Sea Link

Document 9.65: Statement of Common Ground Between National Grid Electricity Transmission and the National Trust.

Planning Inspectorate Reference: EN020026

Version: C
April 2026

Indicative Arrangement of duct, cable and protection at HDD exit

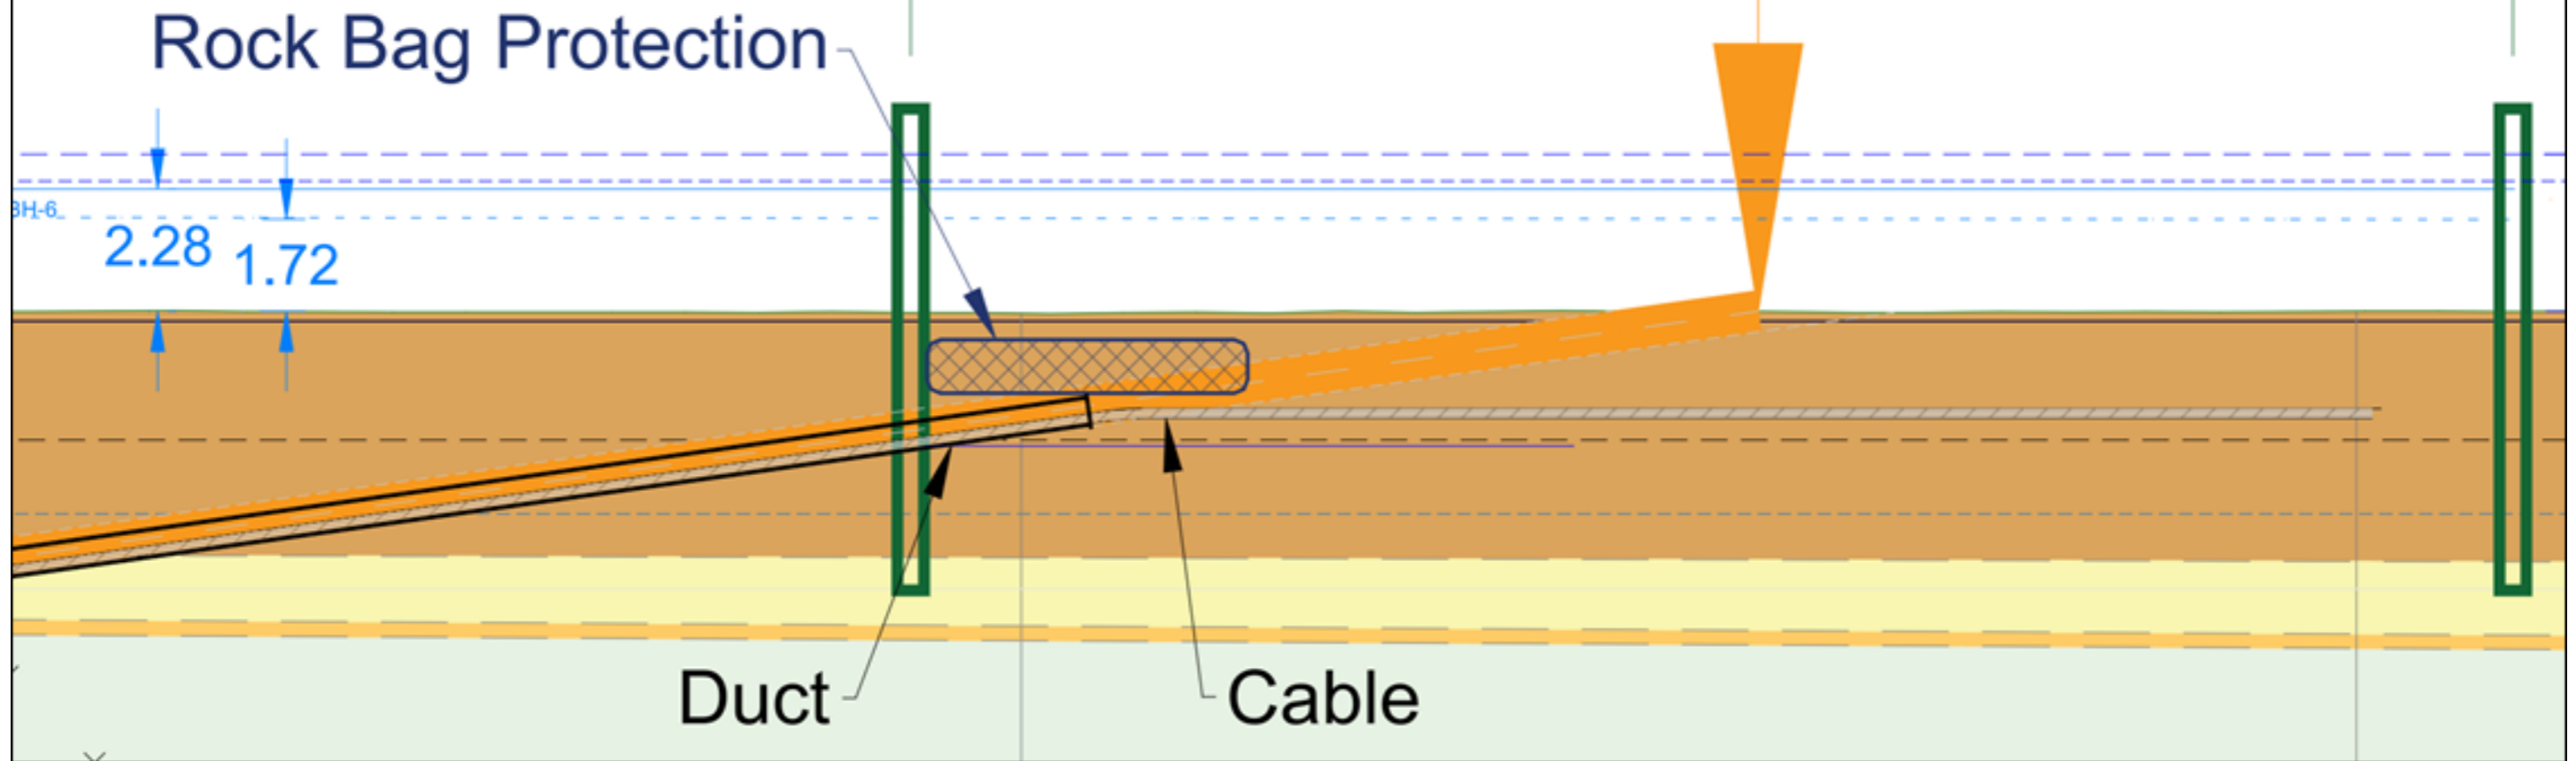
Ref	Relevant Application Documents	Description of Matter	Consultee's Current Position	The Applicant Current Position	Status
			<p>The Trust welcomes the Applicant's confirmation. The Trust seeks in addition that the Applicant completes an HDD Management Plan after first consulting with the Trust and other relevant stakeholders.</p>	<p>the pressure required to drill through the formation, to cause a surface frac out in the SSSI. Therefore, there is a very low risk of frac out.</p> <p>The Applicant can confirm that the HDD contractor will produce a detailed, drilling fluid management plan (B59 of the REAC) to be approved by the MMO in consultation with relevant stakeholders including Natural England and the National Trust, that includes drilling fluid breakout mitigation measures, where HDD is proposed. This is currently secured within the Deemed Marine Licence through Application Document 9.92 (A) Outline Cable Specification and Installation Plan [REP4-090] submitted at Deadline 4, Application Document 7.5.2 (B) Outline Offshore Construction Environmental Management Plan [REP4-223], and also within Application Document 9.84 (B) Register of Environmental Actions and Commitments [REP4-234] under B59.</p> <p>In addition to the above, a HDD Landfall Method Statement will be developed for Pegwell Bay following detailed design which is currently secured within the Deemed Marine Licence through Application Document 7.5.2 (A) Outline Offshore Construction Environmental Management Plan [APP-339]. The National Trust will be consulted on this document. This document [APP-339] was updated and re-submitted at Deadline 5 and now secures all mitigation relevant to the Offshore Scheme including both landfalls. Commitments to monitoring has been included in this document for both Suffolk and Kent landfalls.</p> <p>The Onshore CEMP (section 3.5), and REAC measure GG24 secures the production of an Incident Response Plan. Contact details for the ECoW overseeing works on land owned by the National Trust will be provided to National Trust. Should any environmental issues arise during construction on National Trust's land that are noted by the ECoW, National Trust will be notified and a meeting offered to discuss any actions required, in line with the procedures specified within the Incident Response Plan described in GG24.</p> <p>A list of relevant securing mechanisms for the Proposed Project is provided in Appendix A. In addition to this, a cross sectional image of the HDD exits in the intertidal at Pegwell Bay are presented in Appendix B.</p>
